NAVAL RESEARCH LABORATORY
REPORT

EXPERIMENTAL VLF RECEPTION
A STUDY OF VARIOUS LOOP
COUPLING METHODS

- Report R-2872

OVERALL SENSITIVITY CHARACTERISTICS
OF
COUPLING UNIT SYSTEMS
MICROVOLTS PER METER AT LOOP CENTER
IN AIR VS. FREQUENCY

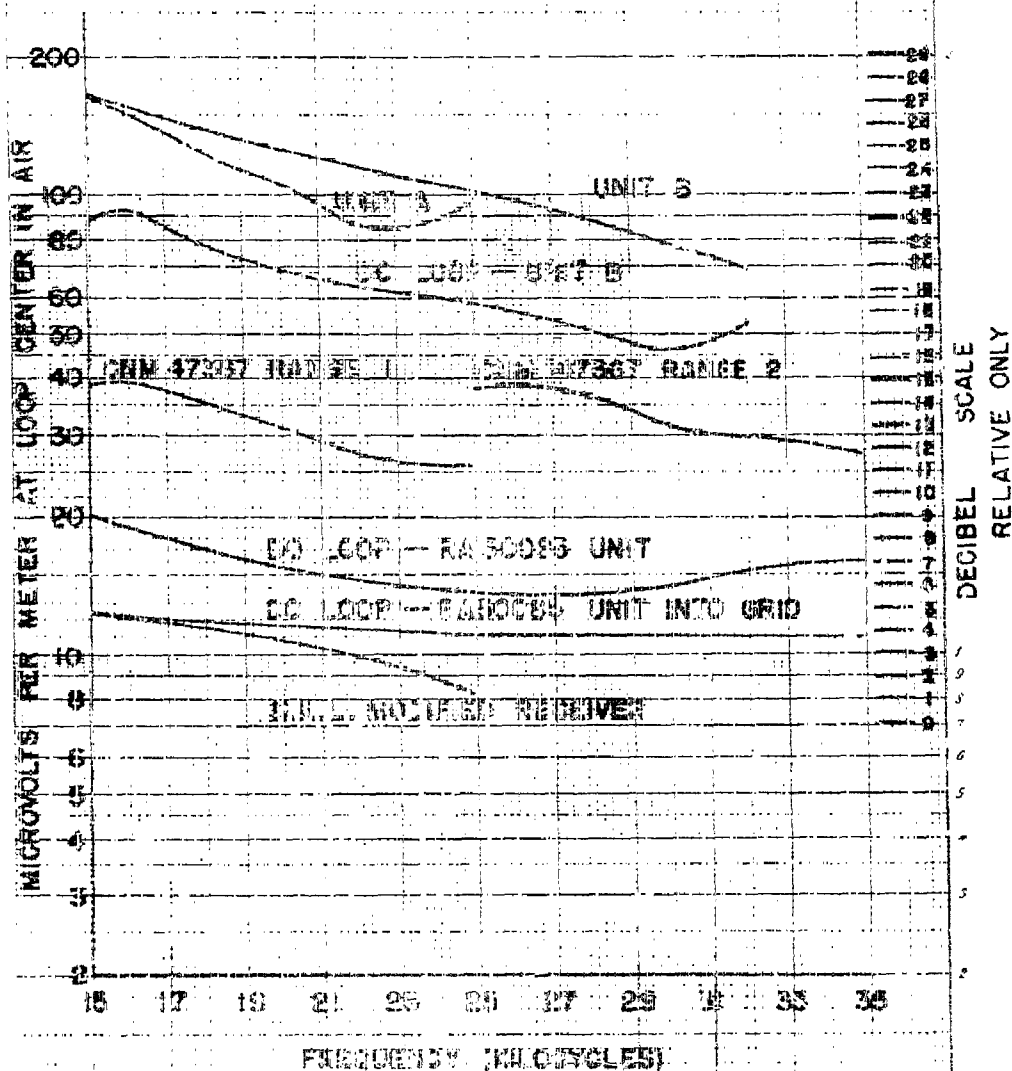
5. The sensitivity of the overall system (GNM 66097 Loop, Mare Island Coupling Unit B, and RAK Receiver) varied from 163 microvolts per meter at 15 Kilocycles to 79 microvolts per meter at 30 Kilocycles. At 25 Kilocycles the sensitivity value was 102 microvolts per meter (Reference Plate 1). The overall sensitivity using the GNM-47367 Coupling Unit varied from 38 microvolts per meter at 15 Kilocycles to 31 microvolts per meter at 30 Kilocycles. The overall sensitivity using the modified Model RAK Receiver (incorporating NRL transformer design, Reference 3), varied from 12.2 microvolts per meter at 15 Kilocycles to 8.2 microvolts per meter at 25 Kilocycles. These data indicate that the present standard GNM 66097 system, using the GNM-47367 Coupling Unit, is about 13 decibels at 15 Kilocycles and about 6 decibels at 30 Kilocycles better than the system using the Mare Island Coupling Units. When the comparison is carried further, it is found that the NRL proposed system using the modified Model RAK Receiver and GNM 66097 Loop is about 23 decibels at 15 Kilocycles and about 21 decibels at 25 Kilocycles better than the system using the Mare Island Coupling Units. Proposed in reference (3), this system modification is understood to be in process of adoption.

8. The curves shown on Plate 1 indicate that neither Mare Island Coupling Unit has a frequency range of 15 to 35 Kilocycles. Unit A frequency coverage lies between 15 and 25 Kilocycles. Unit B between 15 and 33 Kilocycles.

TOP PERSPECTIVE VIEW
HARP ISLAND COUPLING UNIT
UNIT A

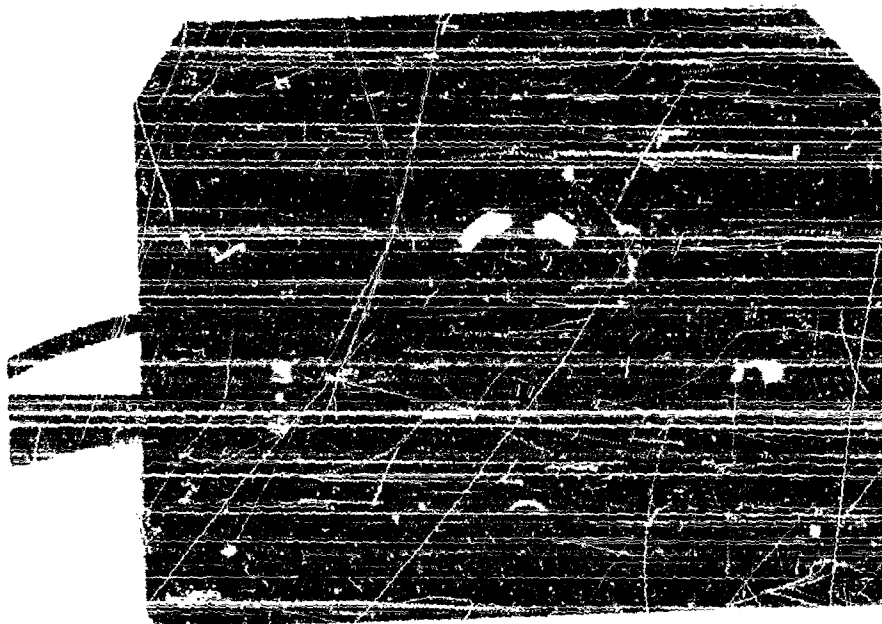
13. Upon inspection of this unit, it was observed that there were numerous undesirable features in the design that did not conform with the standards expected in naval equipment. For example, the dial plate of the variable capacitor should have been provided with a clamp to prevent accidental change of setting (Reference Plates 3 to 5 inclusive); the controls should have been labeled to properly identify them as to their function; it would have been desirable to include mounting brackets to facilitate installation and maintenance; knurled captive thumb screws to secure chassis to cabinet would have been superior to the use of self tapping screws; cable connections to the unit should have been made through proper jacks and plugs, and a tube clamp assembled to the chassis for the 6C6-Gt. tube. Further, the electrical wiring should have been such that all components would have been placed on approved fungus proof terminal boards and properly number designated for immediate identification with no more than three connections made at a terminal. The wiring lead lengths should have been long enough so that no lead would have been excessively long permitting a possible source of added coupling, or too short, allowing stress to exist in the lead. The method of grounding components and circuit points should have been made directly to the chassis in the shortest practicable distance, and the soldering of all components and all electrical circuit leads to terminals should have been such as to insure the electrical connection by making at least two turns around the terminal before the application of the solder. Further, the transformer should have incorporated a rust proof shield to safe guard against physical injury and stray field coupling.

5. That Coupling Unit A have incorporated with the variable capacitor dial plate a clamp to prevent accidental change of setting.
6. That all controls of Coupling Unit A be properly labeled as to function.

FRONT VIEW
MARE ISLAND COUPLING UNIT
UNIT B

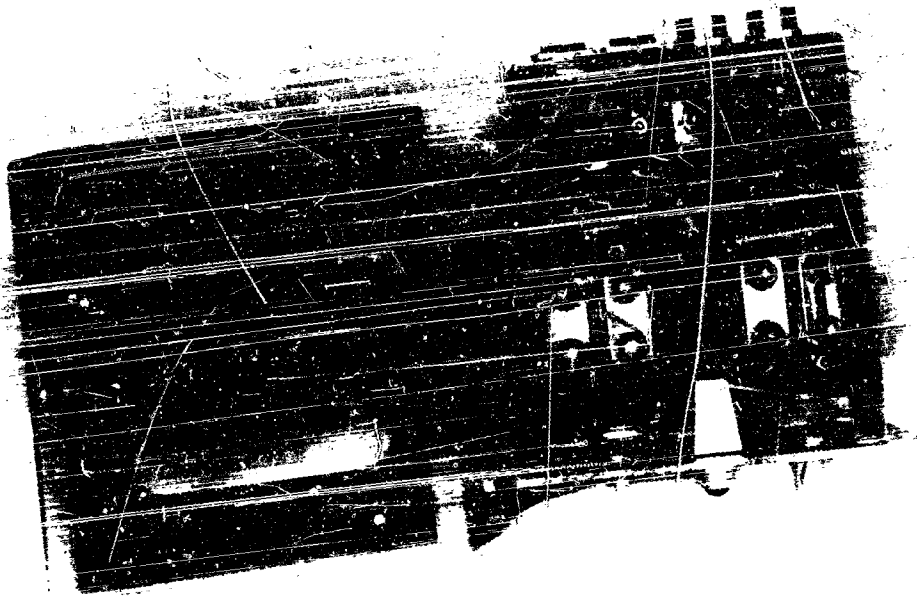
14. Upon inspection of this unit, it was discovered that there were undesirable features in the design of a nature similar to Unit A, but less numerous, that did not conform with the standards expected in naval equipment. These are, briefly, the methods of grounding circuit points and components, the use of self tapping screws to secure chassis to cabinet, the undesignated components, not mounted on approved terminal boards for immediate circuit identification, the absence of a tube clamp for the 6J7 tube and the omission of suitable brackets attached to the cabinet to facilitate installation and maintenance. Further, it would have been desirable if the design of the resonating capacitor was such as to minimize the possible physical damage to the rotor plates that could occur when the dial is set on 100 divisions and the chassis is removed from the cabinet.

14. That the Coupling Unit B resonating capacitor be protected against damage when chassis is not enclosed in cabinet.
